### **OFFICIAL NOTICE AND AGENDA**

Meeting:	ZONING BOARD OF APPEALS
Members:	Nancy Hoffmann, David Burke, Mark Dillman, Dave Oberbeck, Jerry Jarosz, Nan Giese (Alternate), Arlene Kaatz (Alternate)
Location:	Council Chambers at City Hall, 407 Grant Street
Date/Time:	Wednesday, March 15, 2023, at 4:00 p.m.

## **STAFF REPORT**

### Subject: Variance for Athletic Lighting at East High School

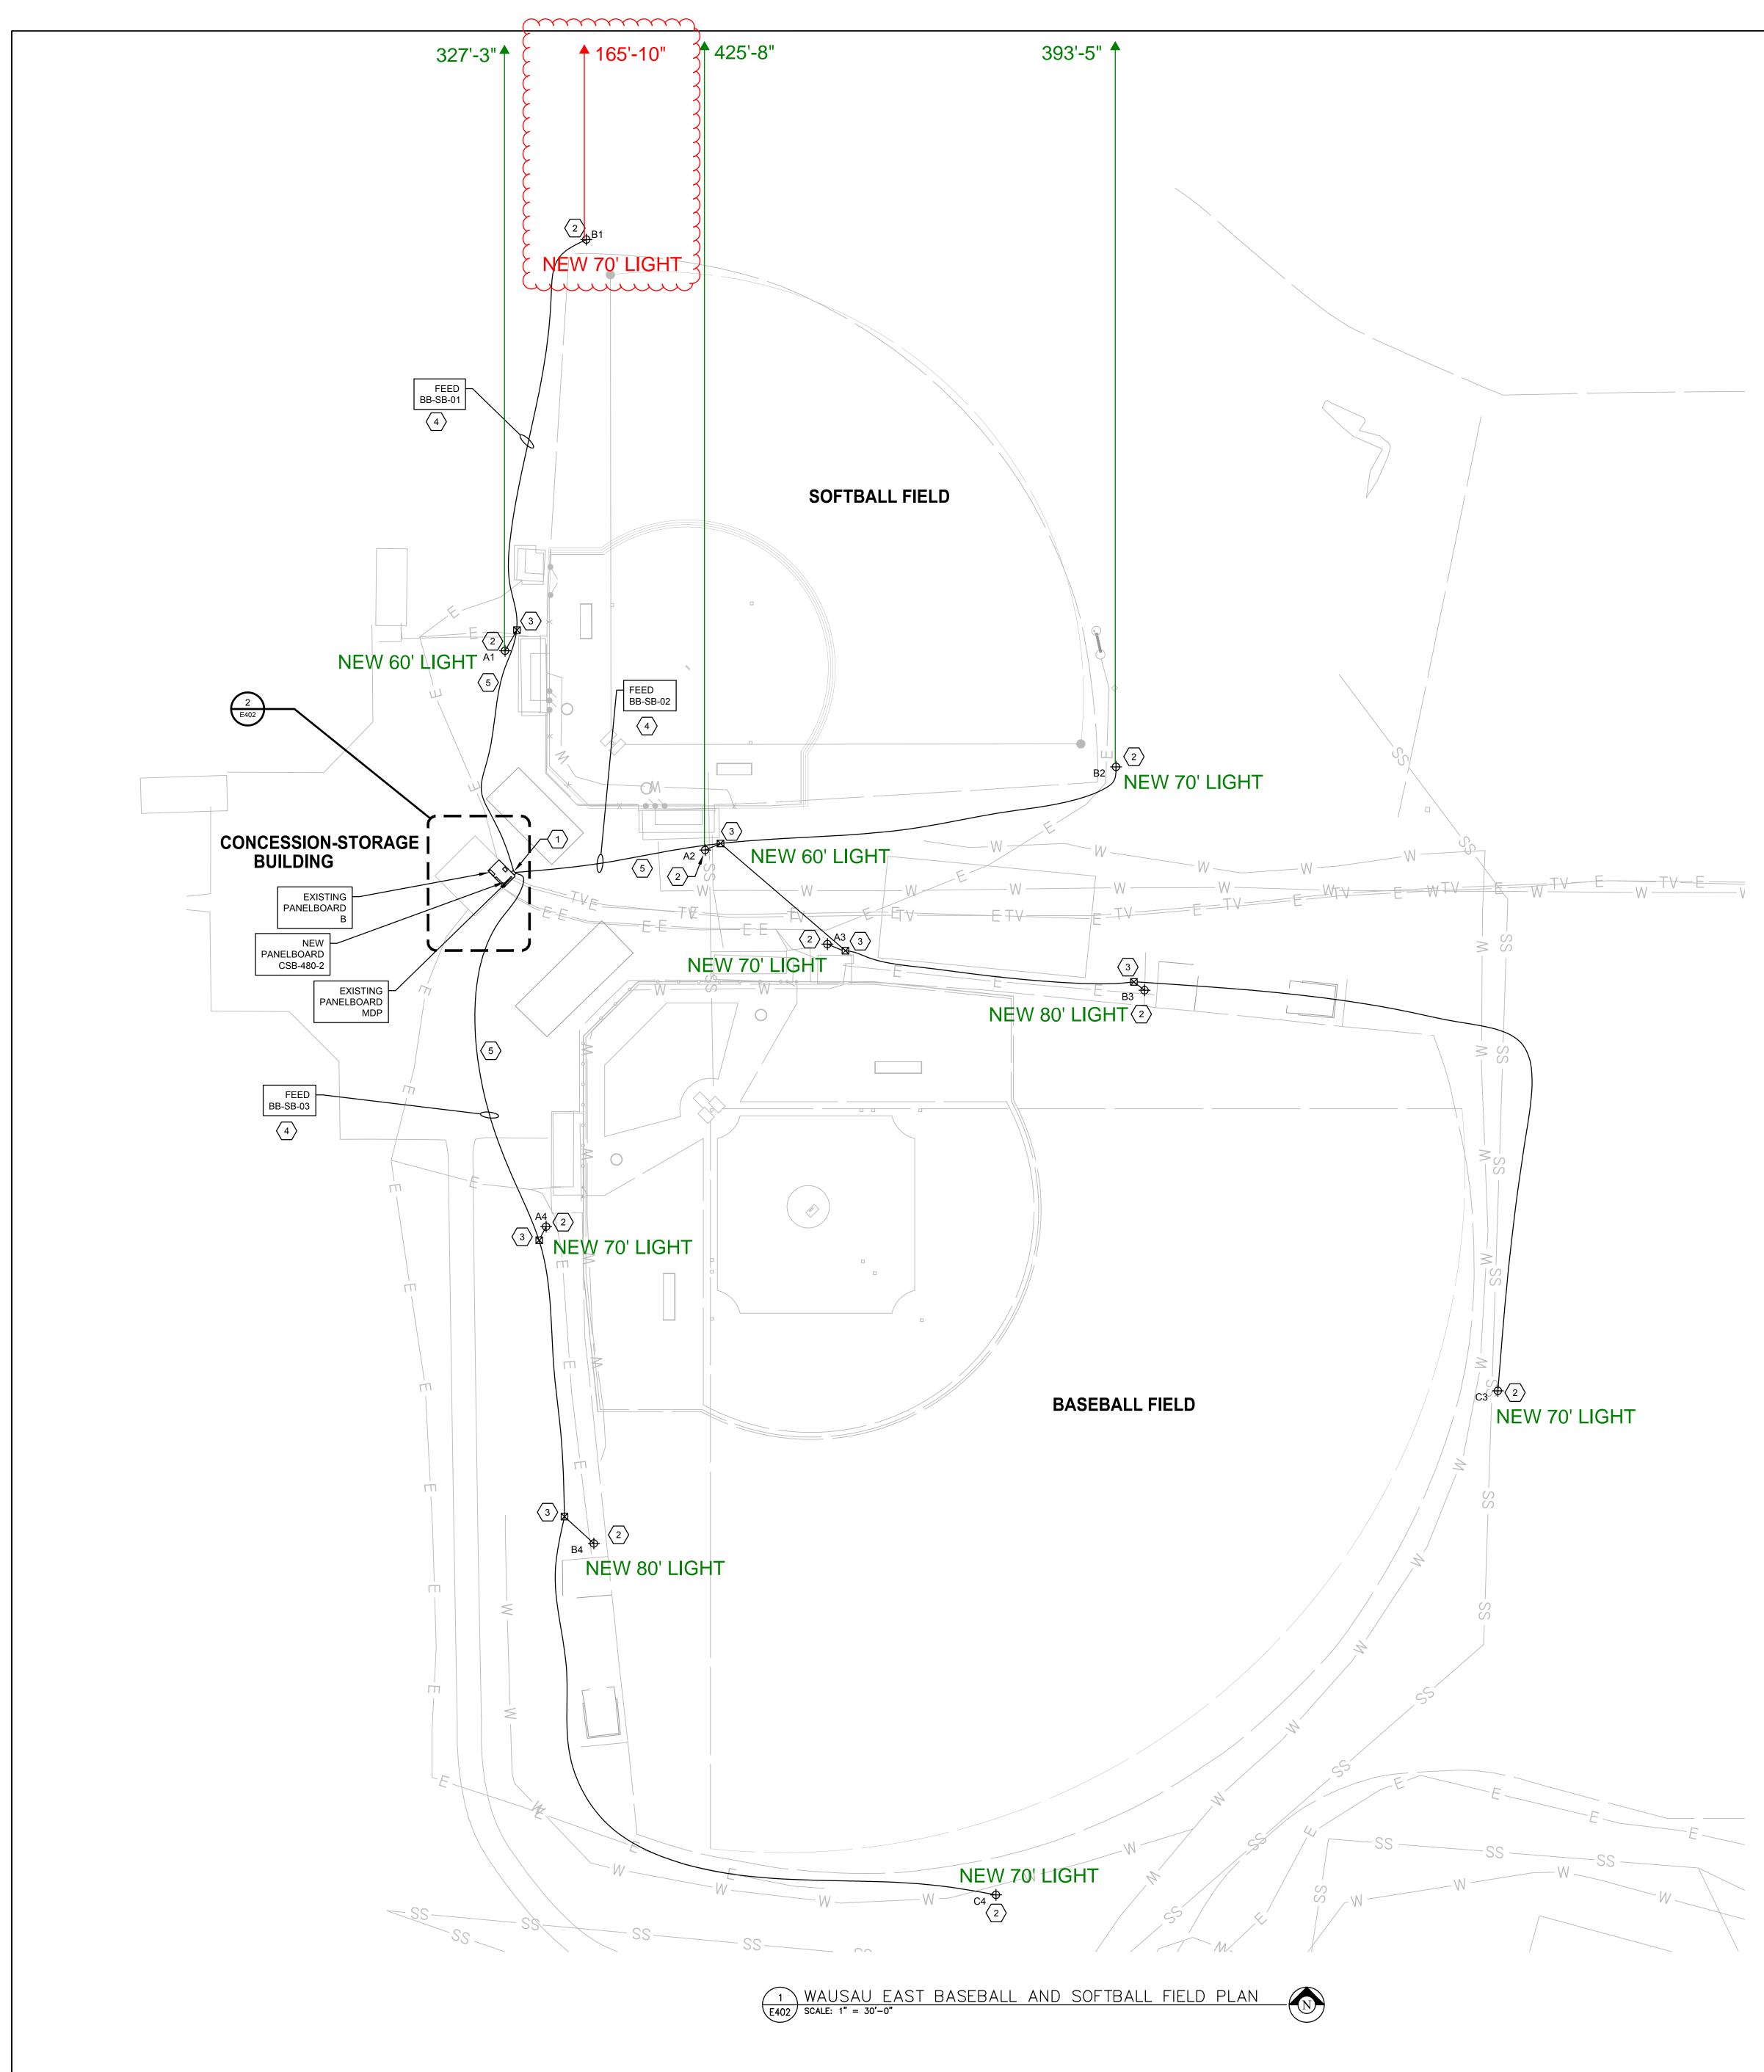
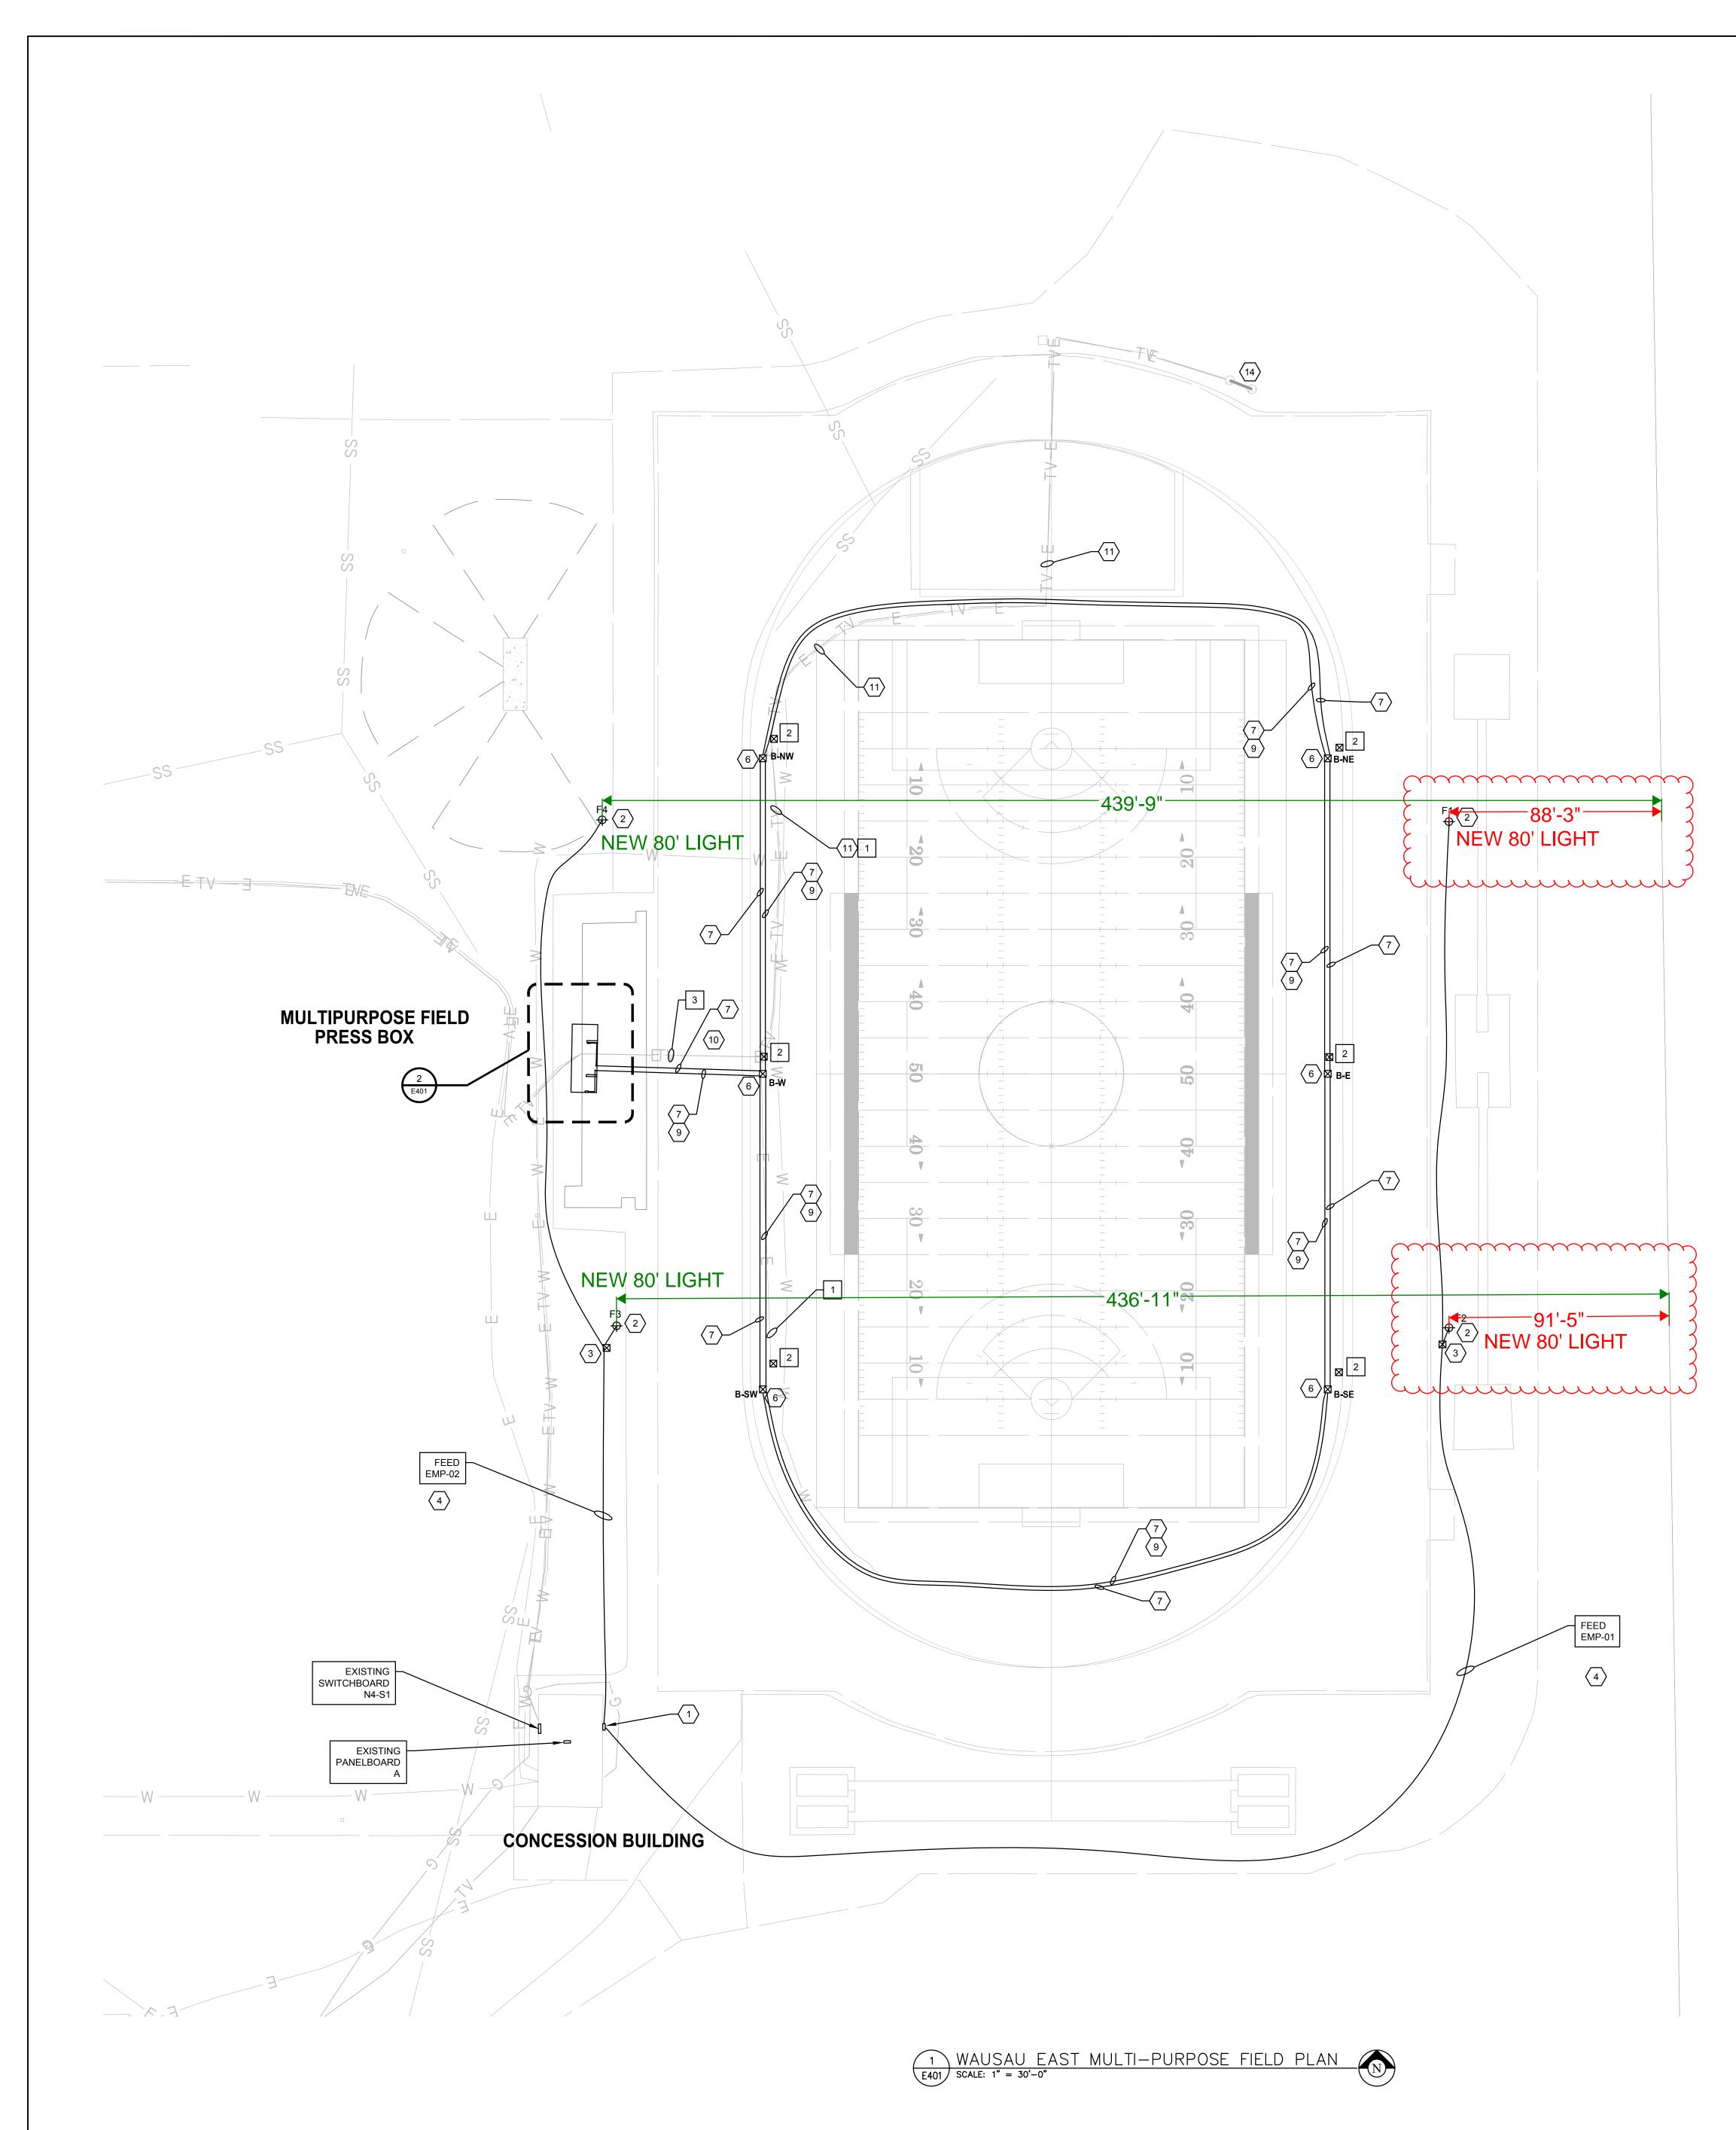
In your packet you will find plans showing the lighting pole height and distance to property lines. Many of the poles that are being proposed are in compliance with the zoning code. Poles that need a variance are clouded around and show pole height and distance to property lines. Also, photometric lighting plans have been included showing that no light spillage will occur over the property lines.

These proposed plans seem to be carefully thought out. Engineered lighting plans have been developed to cut off any light spillage at the property line. The softball and baseball fields have no neighbors close to the fields. The multi-purpose field also has limited neighbors that are impacted. Finally, the tennis court lights are proposed to be placed closer to the property line and public street. This will limit any adverse impact to neighbors on Brown St.
